# CITY OF ALBUQUERQUE

DEVELOPMENT REVIEW BOARD--SPEED MEMO

**DRB CASE NO/PROJECT NO: 1002520**

**RE: Villa de la Cueva/final plat**

**LEGAL DESCRIPTION:**  
 LOTS 15 AND 16, NORTH ALBUQUERQUE AVENUE, BLOCK 1

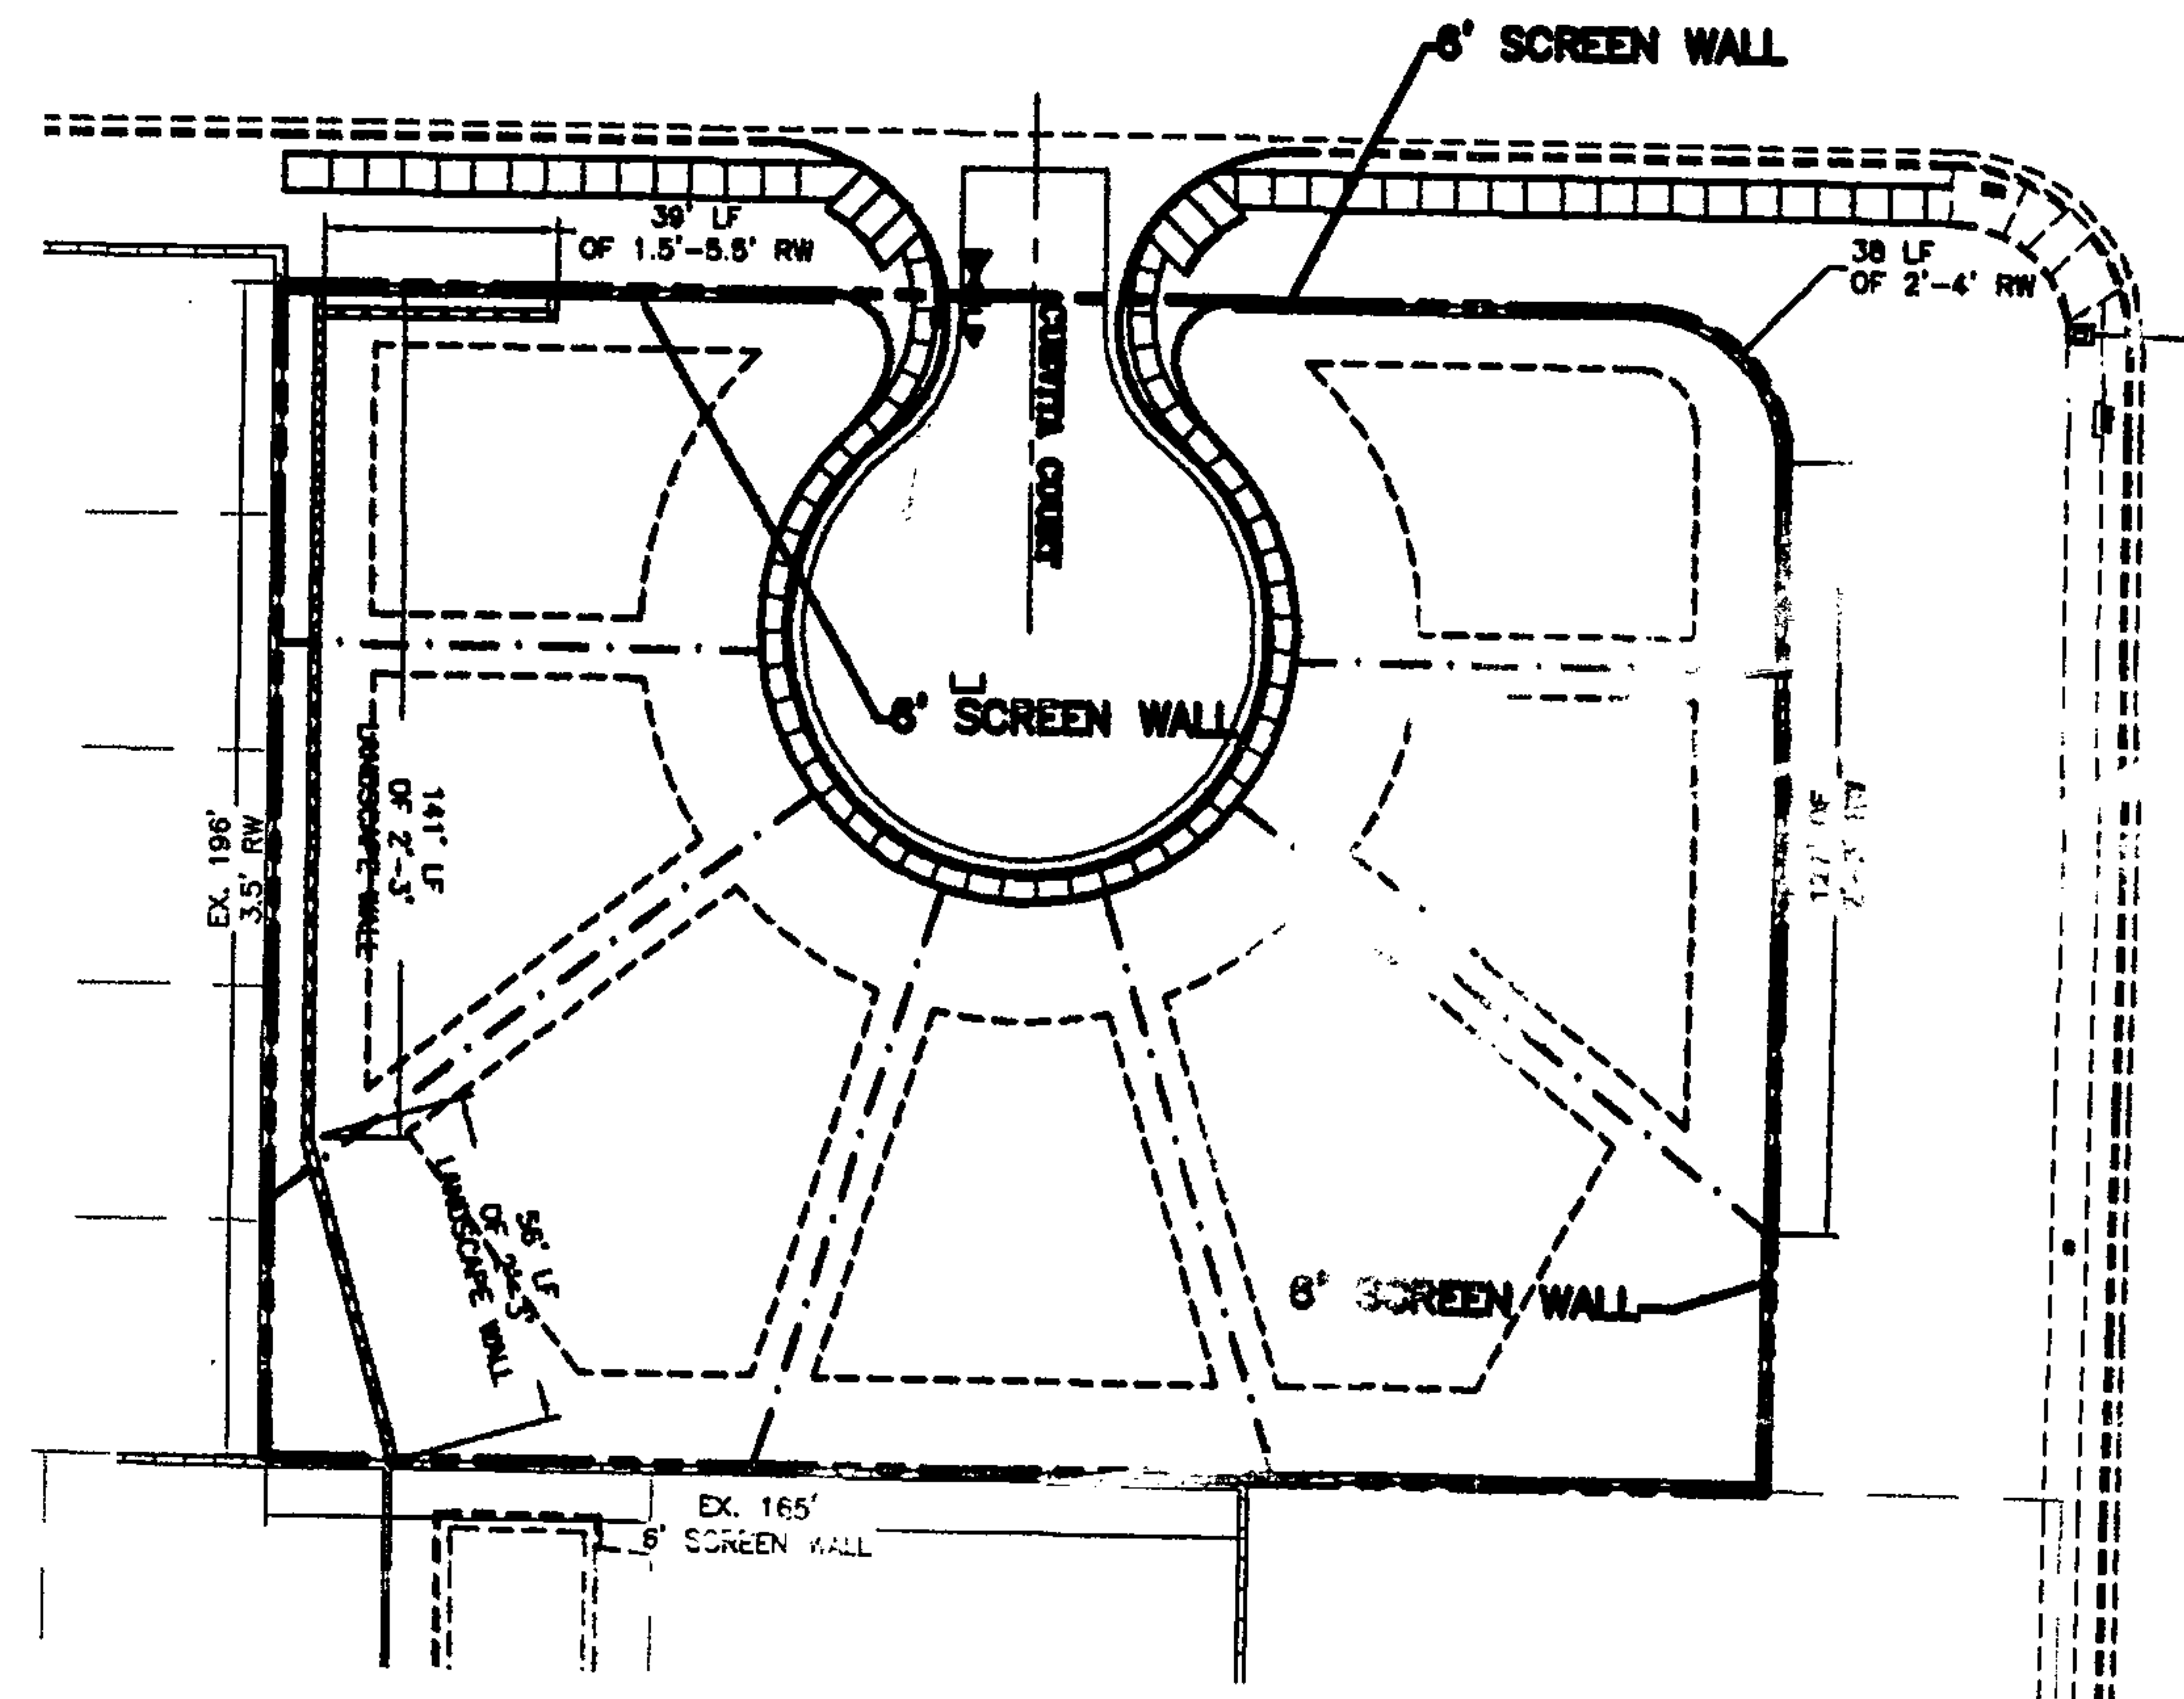
PLANNING (Last to sign): AGIS dx  
Wall design - one correction  
 \_\_\_\_\_  
 \_\_\_\_\_  
 \_\_\_\_\_

- Cuevita Court must be labeled right in/right out only.
- No direct access to Wyoming or Alameda is allowed.
- Wall design submittal shall be revised to reflect Zone Code requirements.

Wall design submittal shall be revised to meet Zone Code requirements.

Perimeter Wall Approved  
*Sharon Watson*  
 DRB Chair  
 10/8/04  
 Date
